TOWN OF WELLS, MAINE
PLANNING BOARD

Meeting Agenda
Monday, March 23, 2026, 7:00 PM
Littlefield Meeting Room, Town Hall
208 Sanford Road

V. **526 POST ROAD SITE PLAN**

Sheet No.:
C2.0

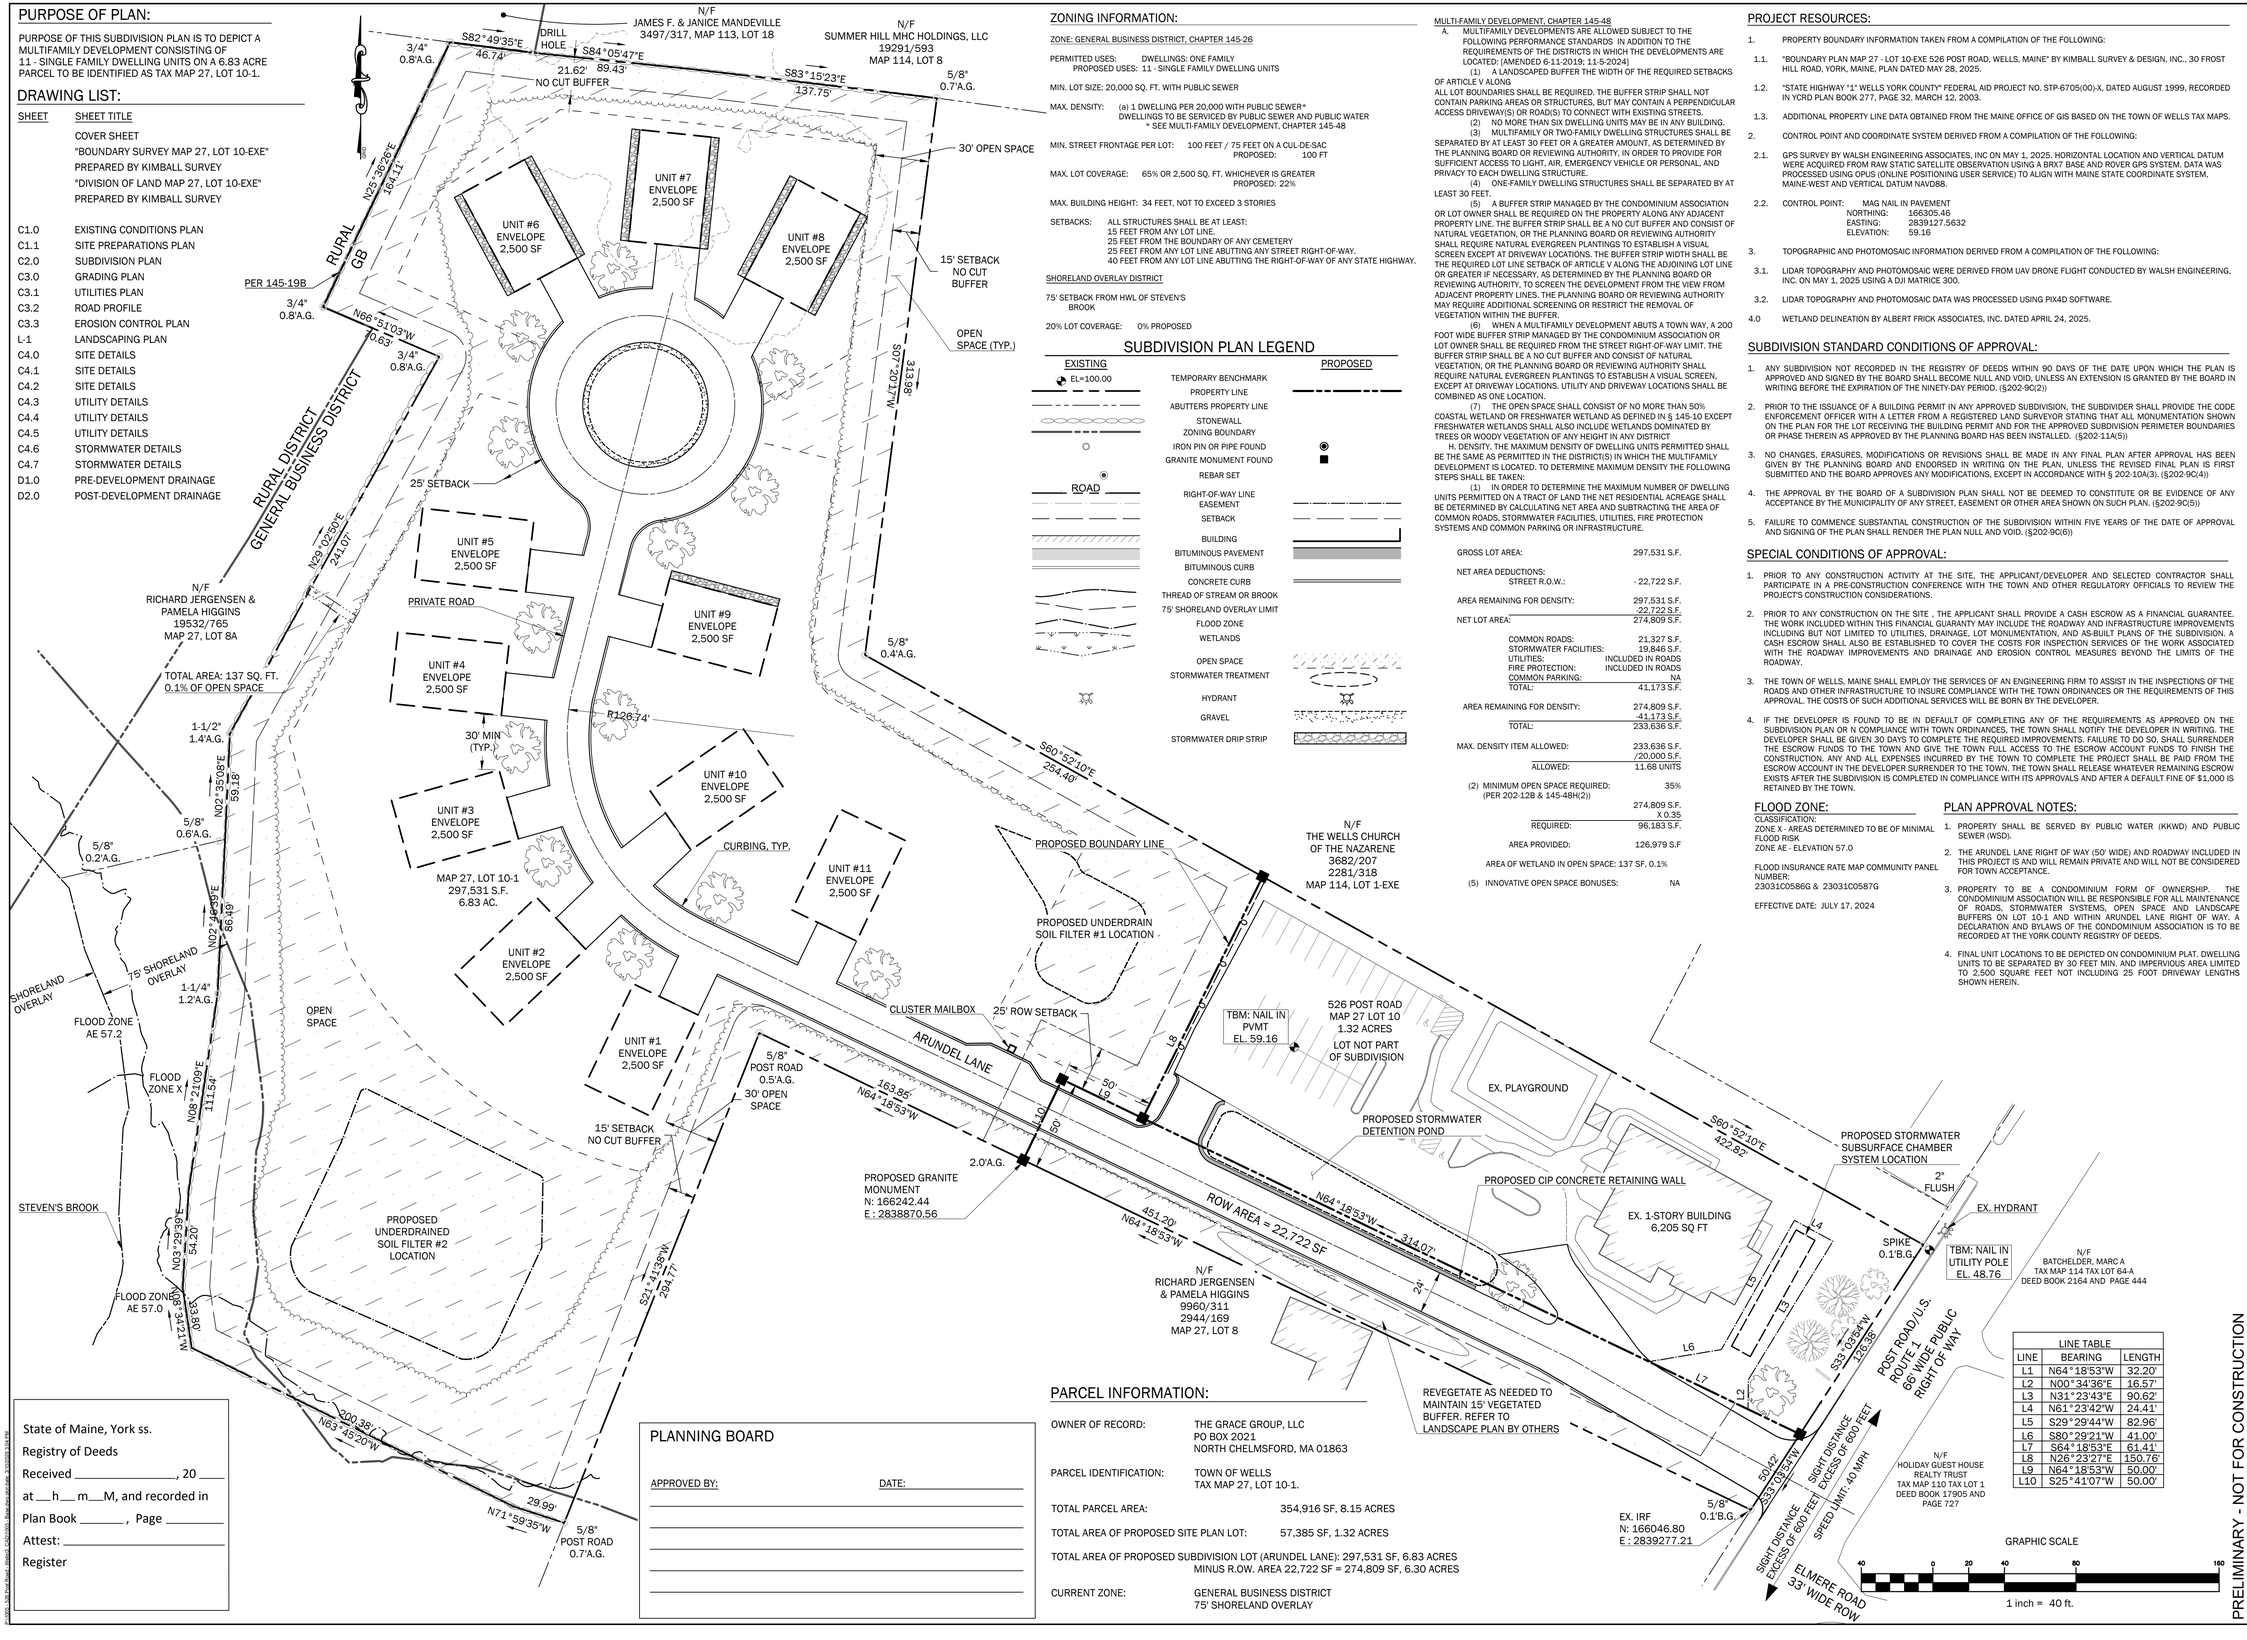
viii. 15' wide setback/ no-cut buffer to be detailed on the plan. Landscaping sheet provided. Planning Board to make buffer determinations after a public hearing. Language for 15' wide setback and no-cut buffer has been revised on plan C2.0, provided with this letter.
ix. The subdivision abuts a residential lot in the rural district (Map 113, Lot 18). Plan to identify what visual screen is proposed for this parcel. Planning Board to review and determine if suitable after a public hearing is determined. Visual screening for residential lot 18 shown on C2.0 is the 20' wide no-cut buffer.

xv. A 25' setback from the internal roadway of the multifamily development is not required. A 25' setback from the lot line abutting the Arundel Lane right of way is required. The setback lines shown on C2.0 of the plan set have been revised to address this comment.

F.(6).a. [3]	Twenty-five feet from any lot line abutting any street right-of-way.	**Parcel does abut the Arundel Lane ROW. 25' setback to be identified.**	Y	C2.0	Proposed 25' setback off of Arundel Lane ROW has been added.
145-48	**PERFORMANCE STANDARDS - MULTIFAMILY DEVELOPMENTS**				
A.(1)	A landscaped buffer the width of the required setbacks of Article V along all lot boundaries shall be required. The buffer strip shall not contain parking areas or structures, but may contain a perpendicular access driveway(s) or road(s) to connect with existing streets	15' wide landscaped buffer along all lot lines noted. **Label corrections needed.** Arundel Lane roadway serving the multifamily development crosses the buffer required from the street ROW.	Y	All Sheets	Labels for the proposed 15' landscaped buffers for the multifamily development have been updated accordingly on all sheets.
A.(4)	One-family dwelling structures shall be separated by at least 30 feet.	**Single family dwellings shall be separated by a minimum of 30 feet. Measurements between the units on the plan appear to be 28 or 29', not 30'.** **Plan provided is not to scale.**	Y	All Sheets	Confirmation that all building envelopes are separated by 30 feet. Plans have been printed with correct margins to provide accurate scale.

ITEM NUMBER	DESCRIPTION	STAFF COMMENT 2/20/2026	COMMENT ADDRESSED	DRAWING / SHEET NUMBER	COMMENT RESPONSE 3/10/2026
F.(3)	Minimum street frontage per lot: 100 feet, which may be reduced to 75 feet for frontage entirely on a cul-de-sac	**The subdivision lot depicts 100' of street frontage on Arundel Lane ROW.**	Y	C2.0	No response necessary
F.(4)	Maximum lot coverage: 65% (20% within the Shoreland Overlay District) or 2500 square feet, whichever is greater, except that the maximum lot coverage shall be 40% of the entire lot on any lot that was legally created prior to January 1, 1994, if at least 75% of the lot is located within the Shoreland Overlay District	The 65% maximum lot coverage of the GB zone is noted on the plan. The proposed lot coverage is 22%. The 2,500 SF boxes on the plan are building envelopes.	Y	C2.0	No response necessary
F.(6).a. [3]	Twenty-five feet from any lot line abutting any street right-of-way.	**Parcel does abut the Arundel Lane ROW. 25' setback to be identified.**	Y	C2.0	Proposed 25' setback off of Arundel Lane ROW has been corrected.
